NUMBER D2-14934-5

TITLE WS-133A Maintainability Progress Report (U)

MODEL NO. SM-80A  
WS-133A CONTRACT NO. AF04(648)-289

CALC			REVISED	DATE	PROJECTED FAILURE RATE LF MOTOR-GENERATOR D-C INPUT CABLE - MALMSTOM	
CHECK						
APR						
APR						
By:	Henschel	3-21-3			THE BOEING COMPANY	PAGE

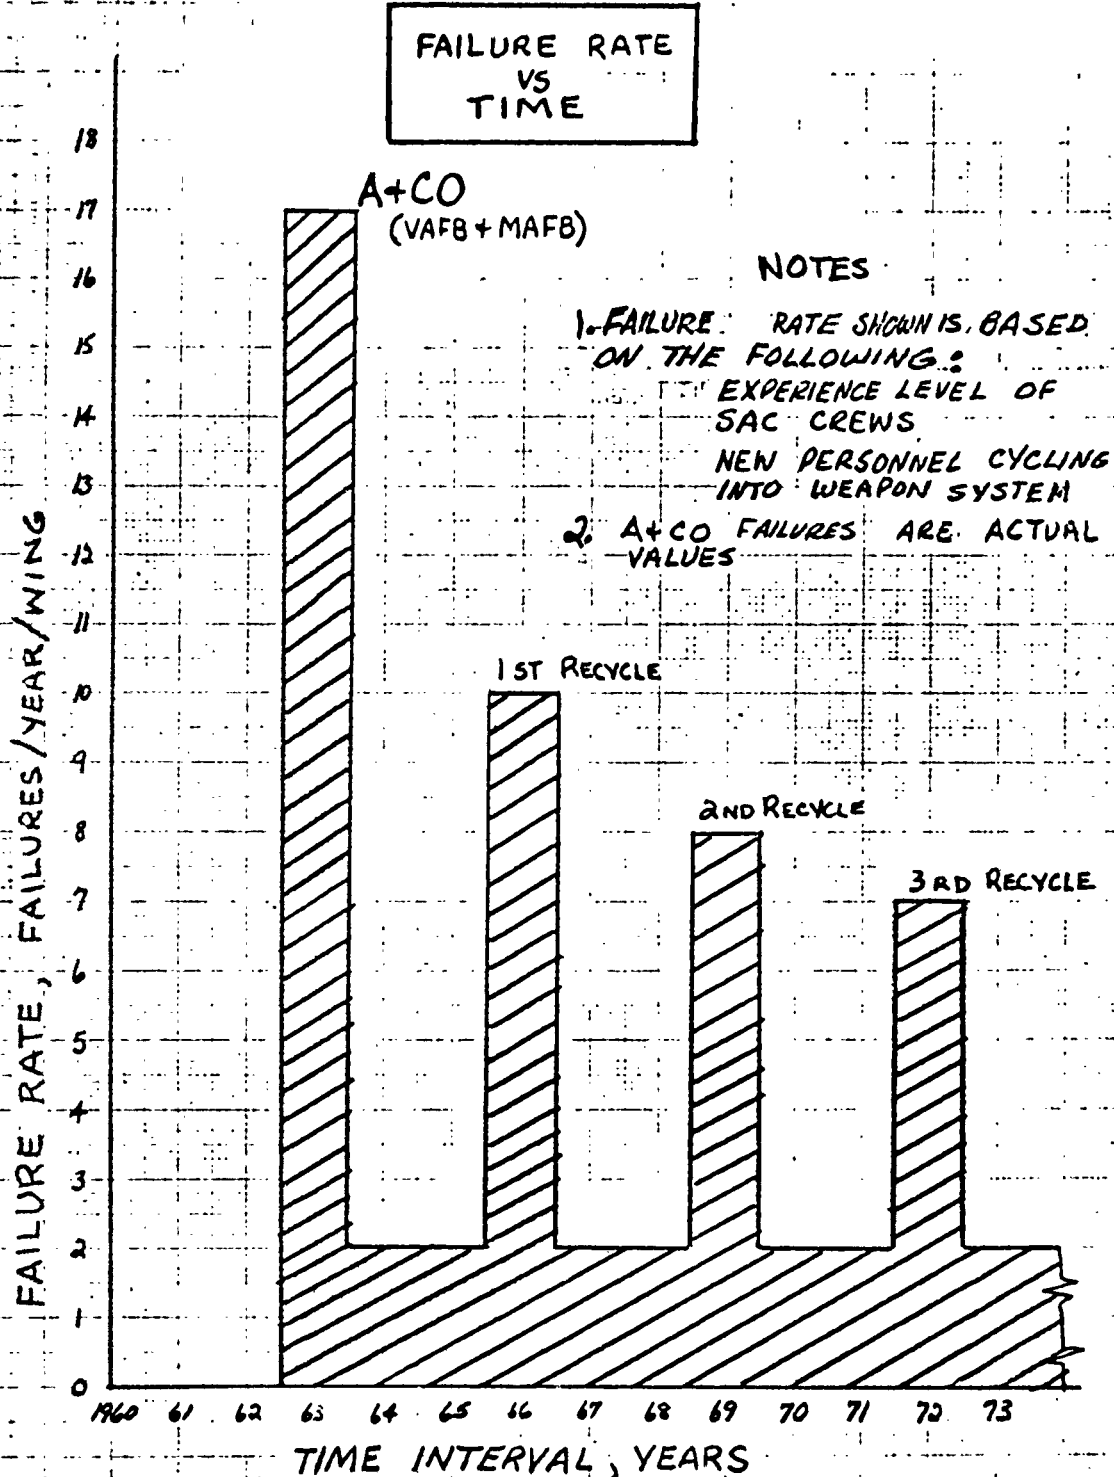
800 placards are needed

Assume a nominal cost of

\$50/LF to properly placard

Cost = \$40,000
